<u>PROJECT ADDRESS</u>	9603 SE 61ST PL MERCER ISLAND, WA 98040
<u>PROJECT NUMBER</u>	TBD
<u>ASSESSOR'S PARCEL #</u>	4260000020
<u>LEGAL DESCRIPTION</u>	LOT 2 OF LELAND ADDITION, AS PER PLAT RECORDED IN VOLUME 82 OF PLAT, PAGE 19, RECORDS OF KING COUNTY AUDITOR; SITUATE IN THE CITY OF MERCER ISLAND, COUNTY OF KING, STATE OF WASHINGTON.
<u>PROJECT DESCRIPTION</u>	SCOPE INCLUDES A MAIN FLOOR ADDITION (173.53 SF) AND UPPER LEVEL ADDITIONS (493.71 SF) TO EXISTING SINGLE-FAMILY HOME, INCLUDING INTERIOR ALTERATIONS PER PLAN. IN ADDITION, NEW 198 SF DETACHED MODULAR SHED TO BE ADDED PER PLAN.
<u>ZONE</u>	R-15
<u>BUILDING TYPE</u>	SINGLE FAMILY RESIDENCE

During the course of construction, extensive framing rot was encountered and a few alterations were made as a result of the need to re-frame those areas. We are proposing to alter the STAR atrium roof framing from a Gable to shed as part of the rebuild. The new roof form will be lower than the proposed building height as previously permitted and below the MAX allowable building height. Additional changes that occurred as a result of demo discovery and rot repair are using closed cell insulation throughout the roof cavity, new siding scope

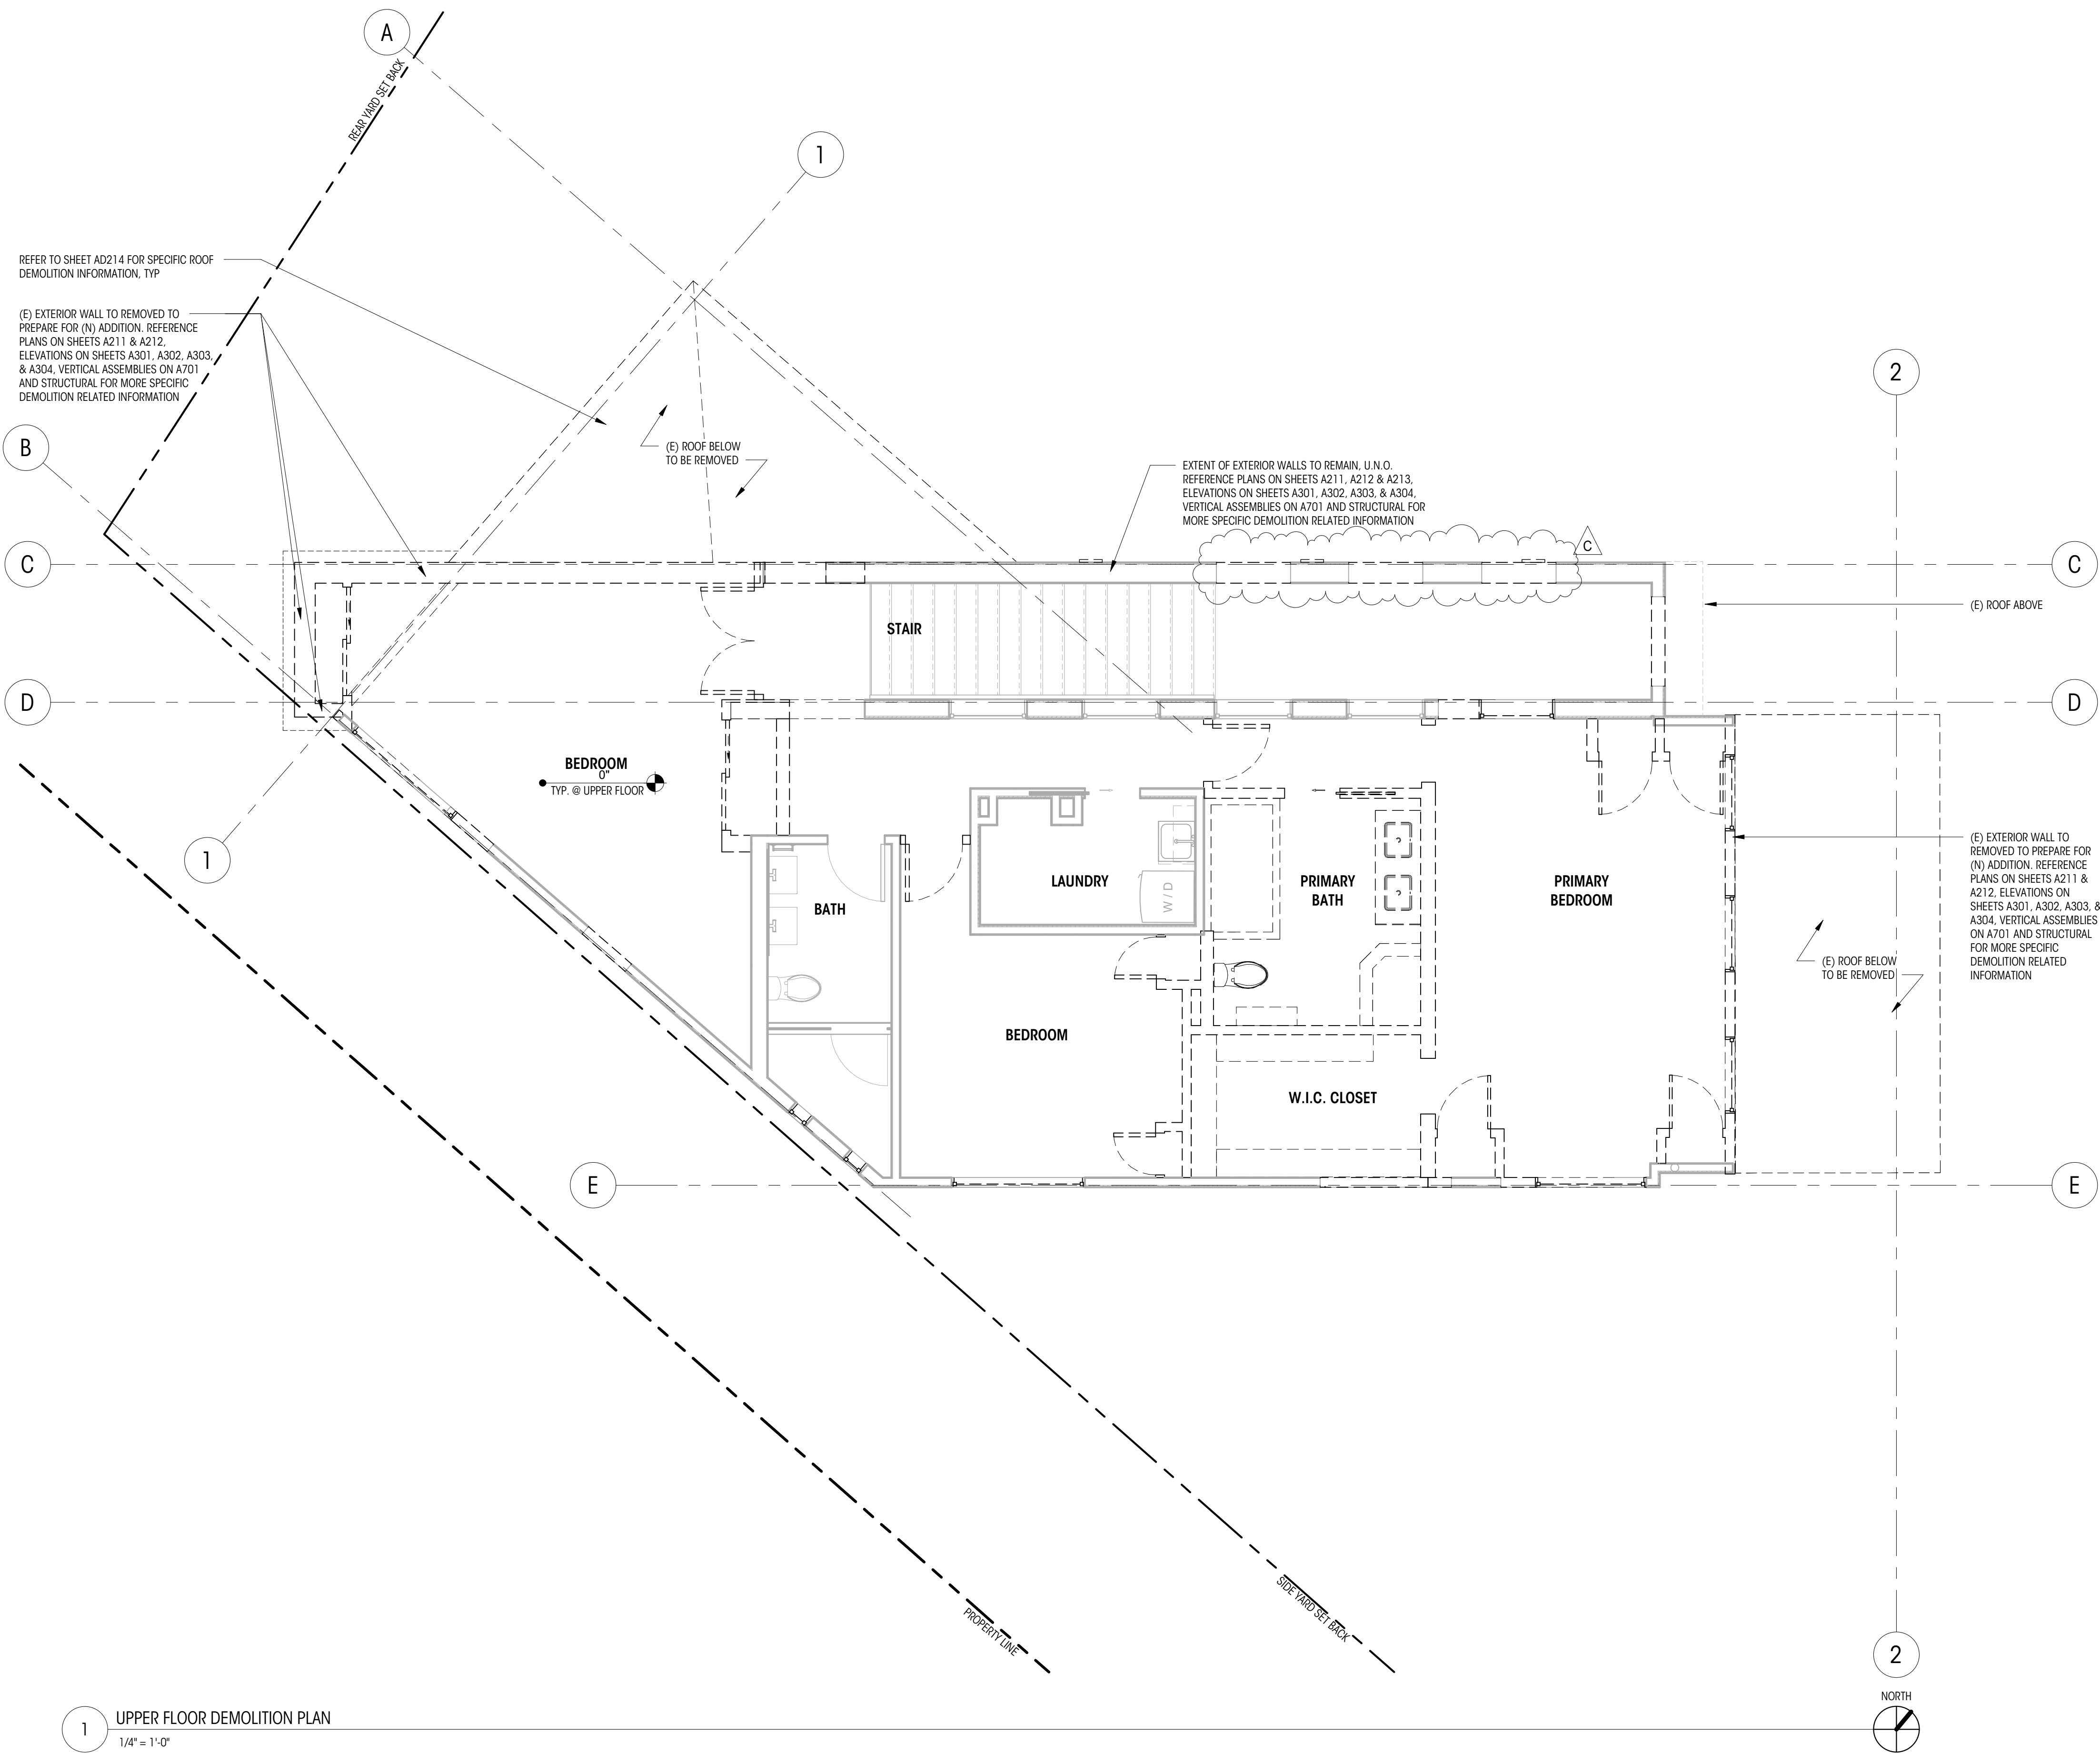
- FRAMING DEMO AS A RESULT OF DISCOVERED ROT

1 ROOF DEMOLITION PLAN
1/4" = 1'-0"

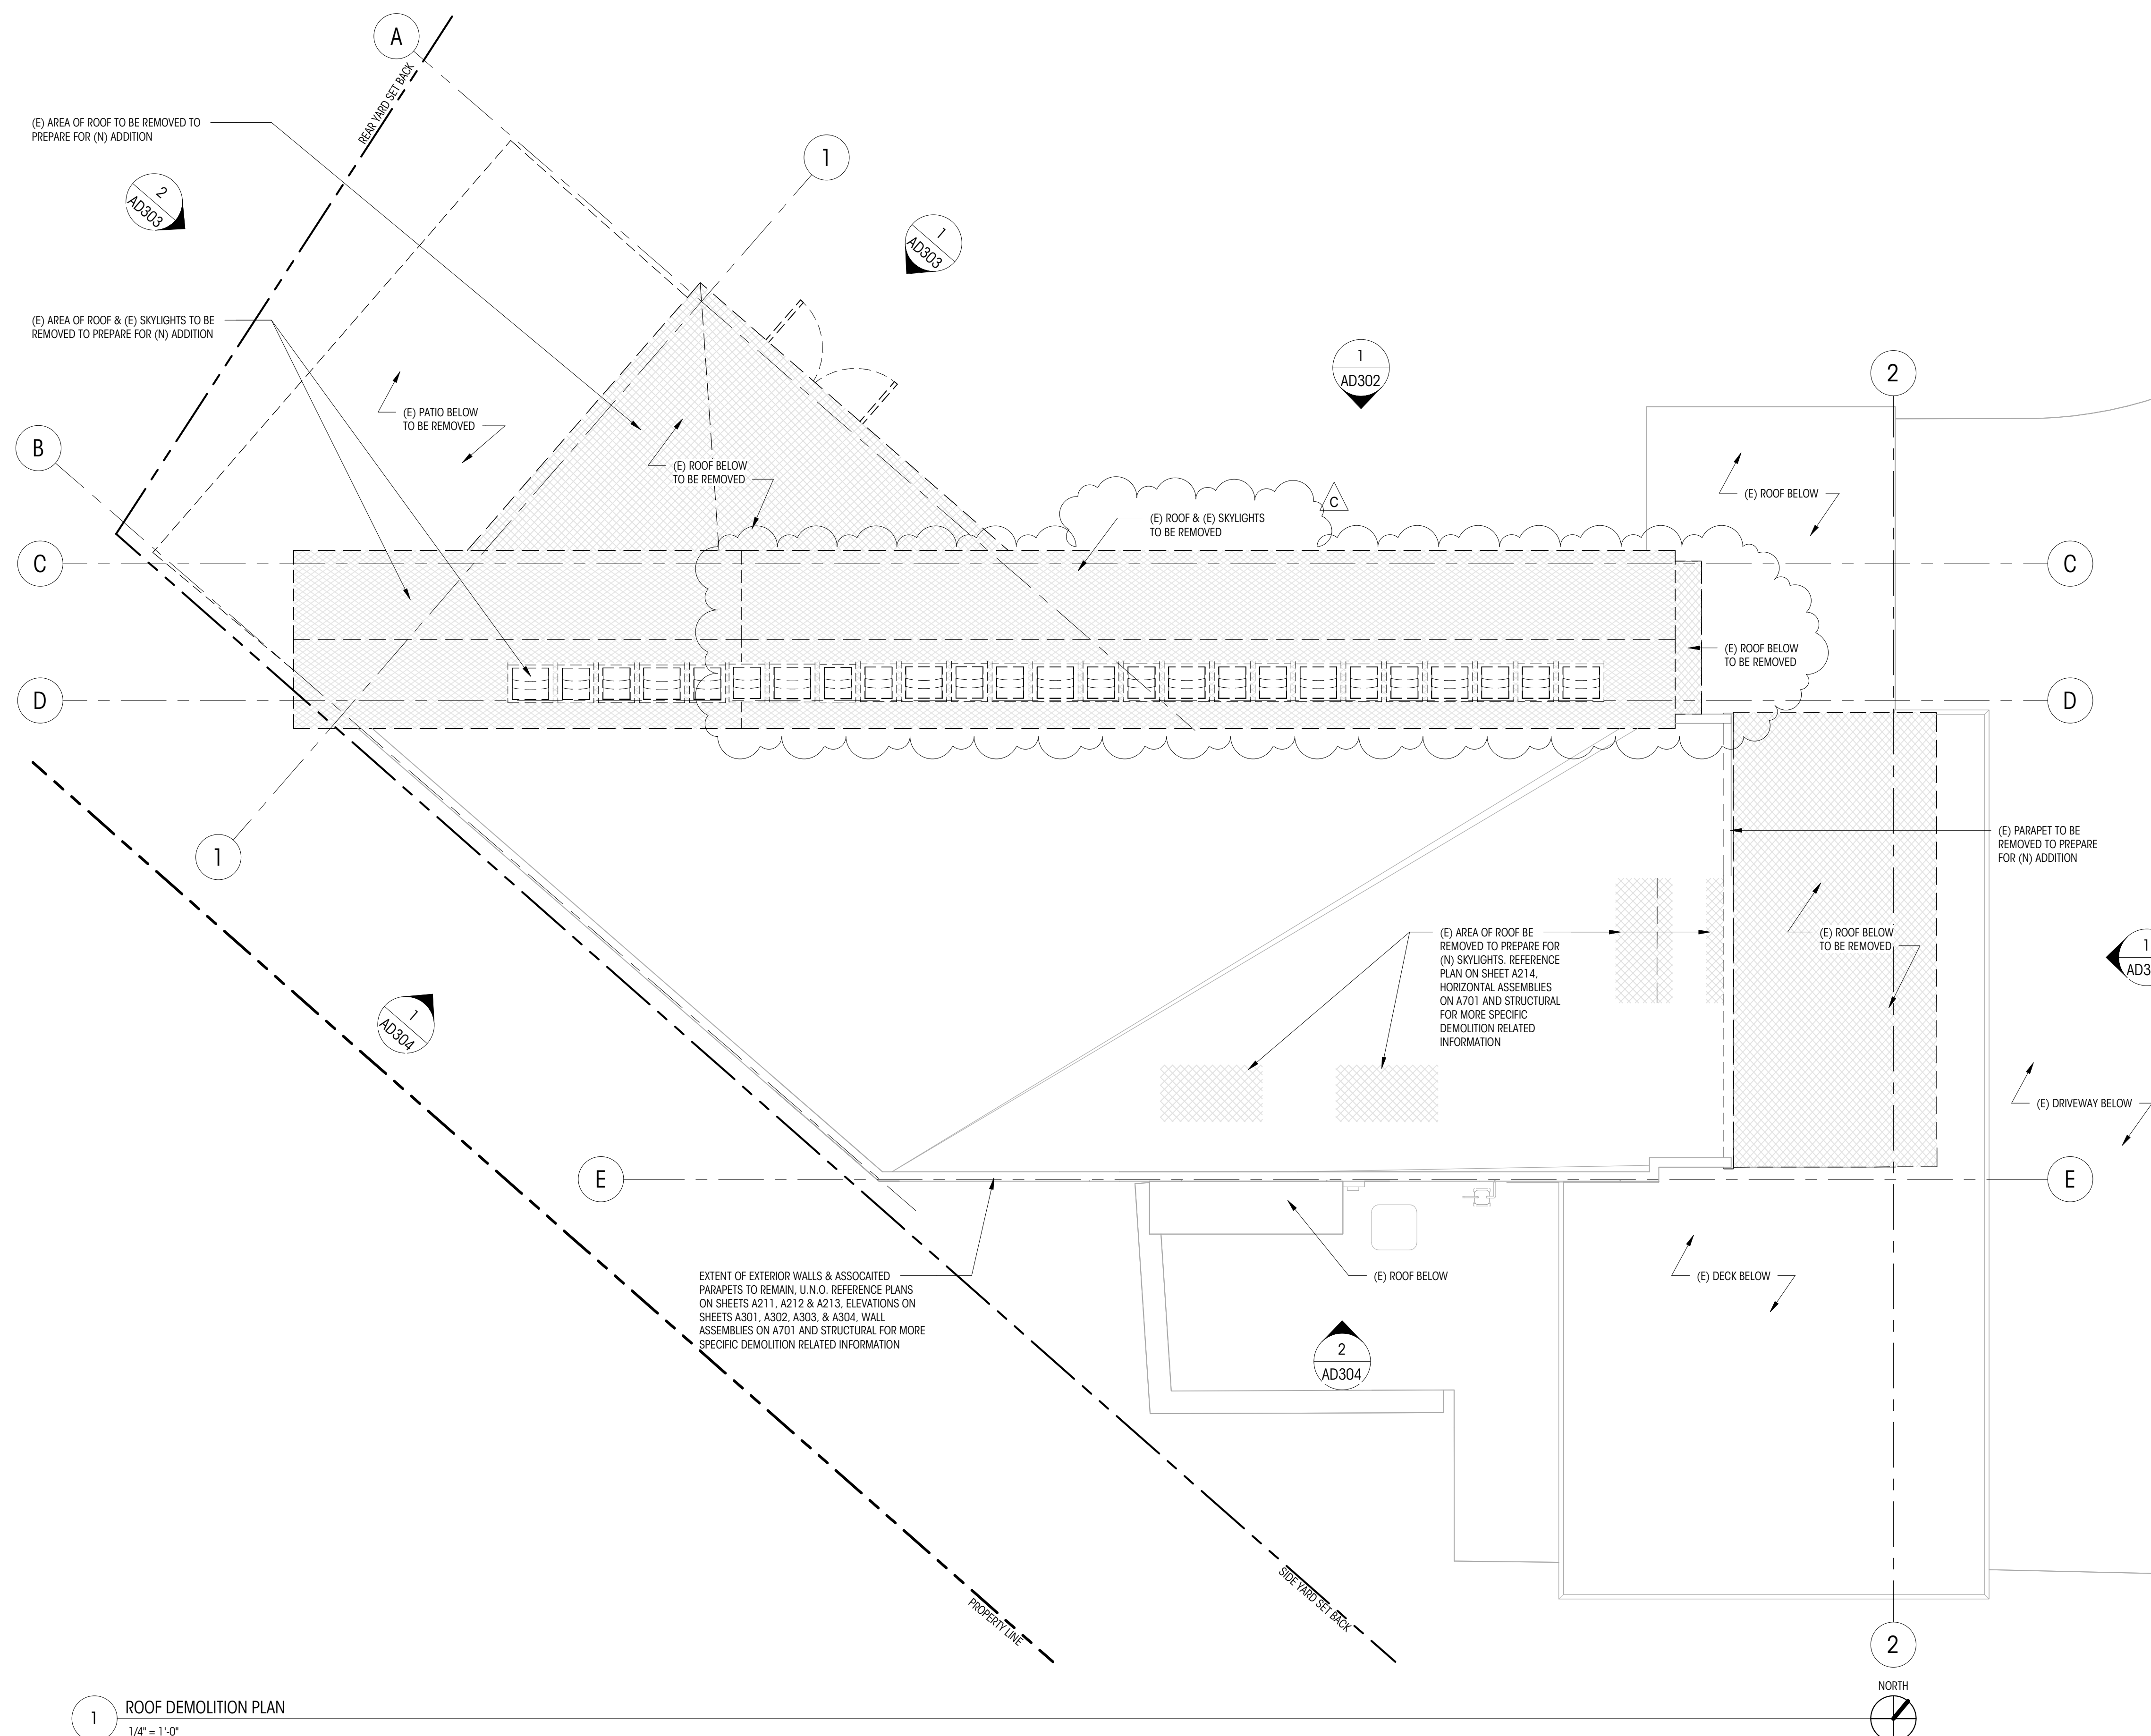
- EXISTING ROOF TO BE REMOVED DUE TO DAMAGE FROM ROOF ROT. NEW ROOF TO BE INSTALLED BELOW THE MAX. BUILDING HEIGHT, WITH NO PROPOSED CHANGE TO LOT COVERAGE OR HARDSCAPE

1 EXTERIOR DEMOLITION ELEVATION - NORTH
1/4" = 1'-0"

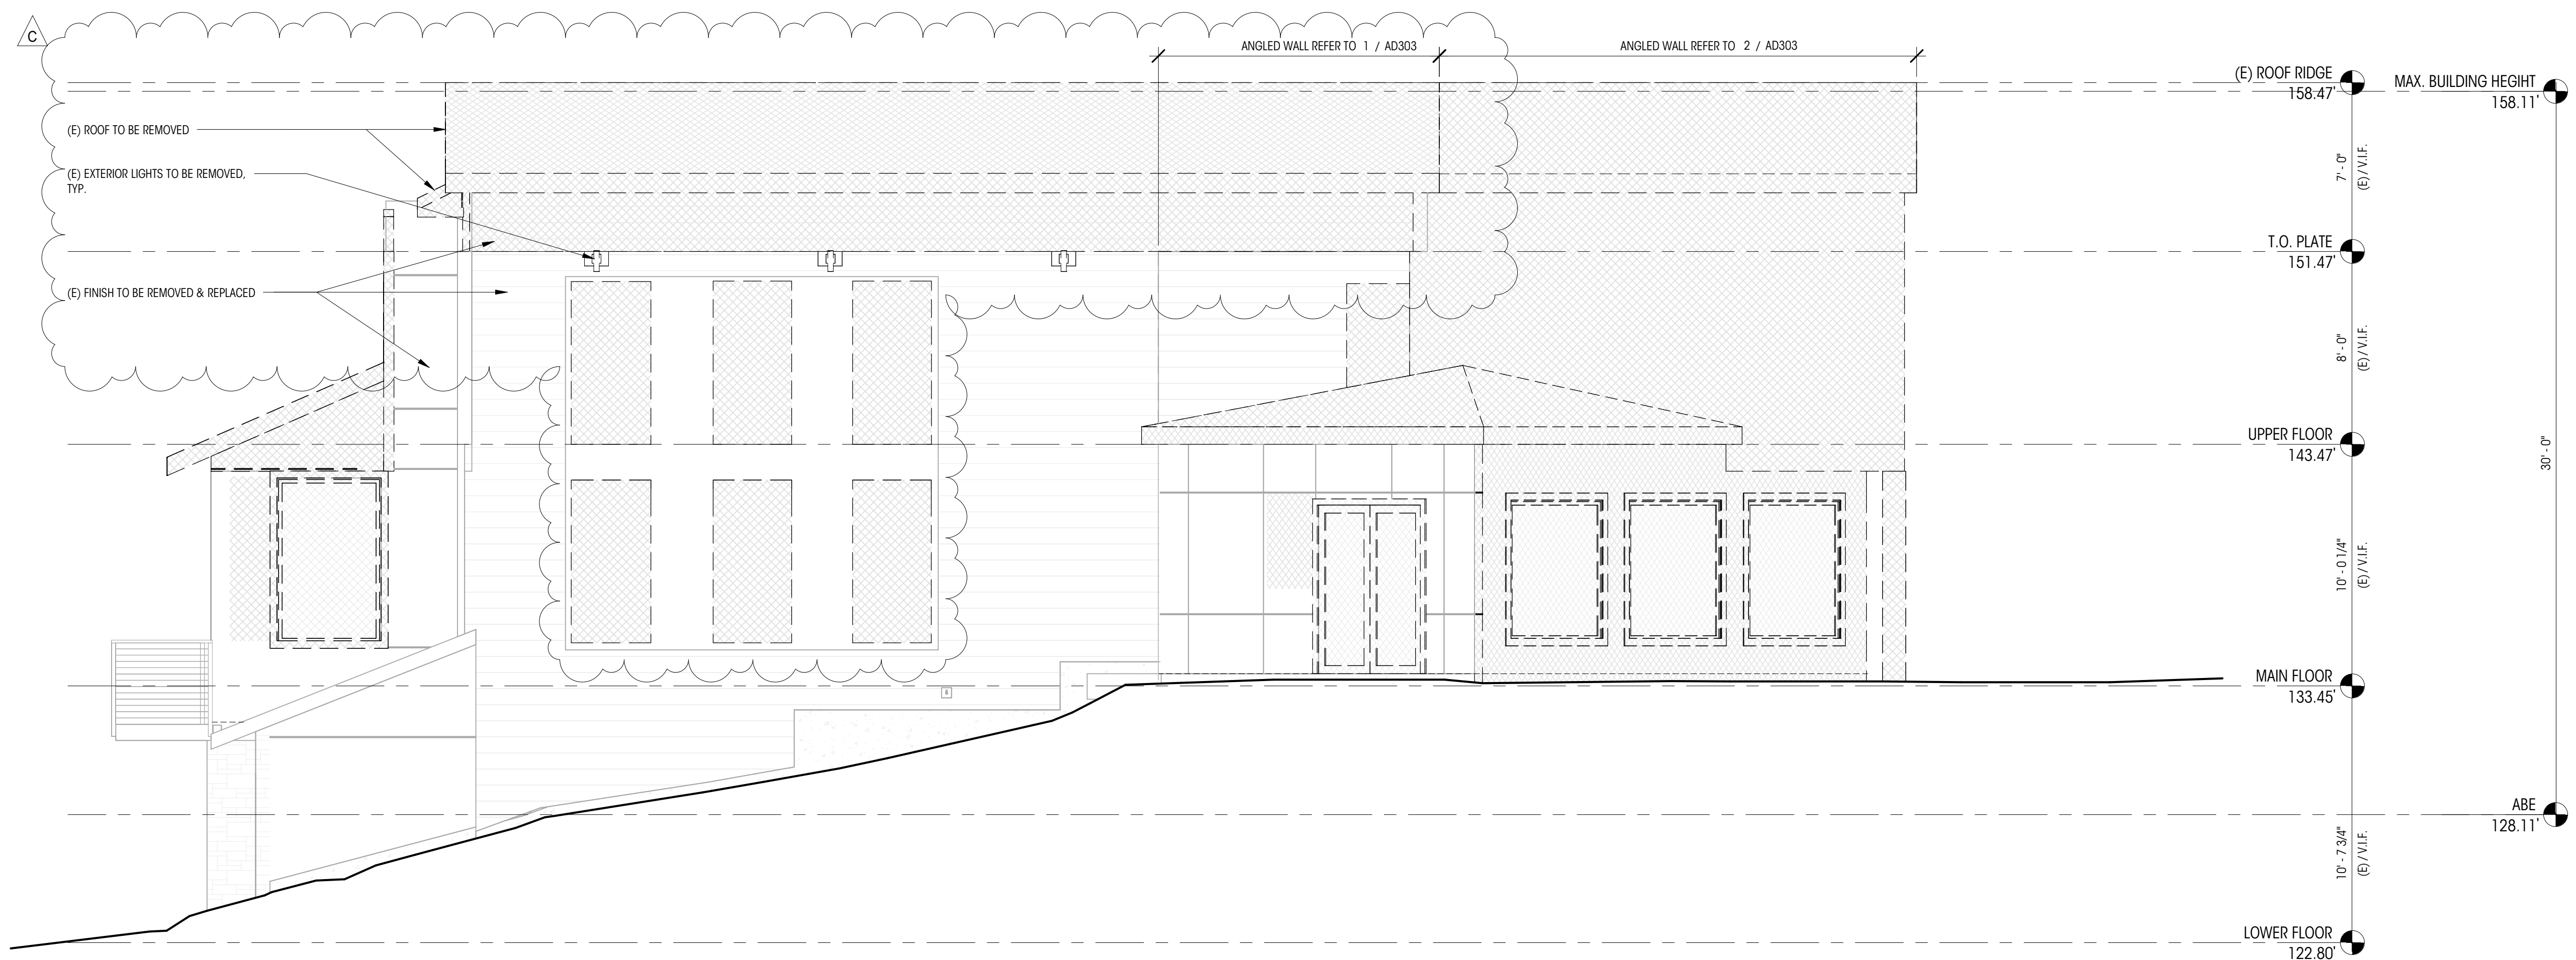
- EXISTING ROOF TO BE REMOVED DUE TO DAMAGE FROM ROOF ROT. NEW ROOF TO BE INSTALLED BELOW THE MAX. BUILDING HEIGHT, WITH NO PROPOSED CHANGE TO LOT COVERAGE OR HARDSCAPE.
- WALL ROT; EXISTING SIDING, SUBSTRATE AND FRAMING TO BE REMOVED AND REPLACED IN PLACE. GC TO VERIFY EXTENTS OF DAMAGE.
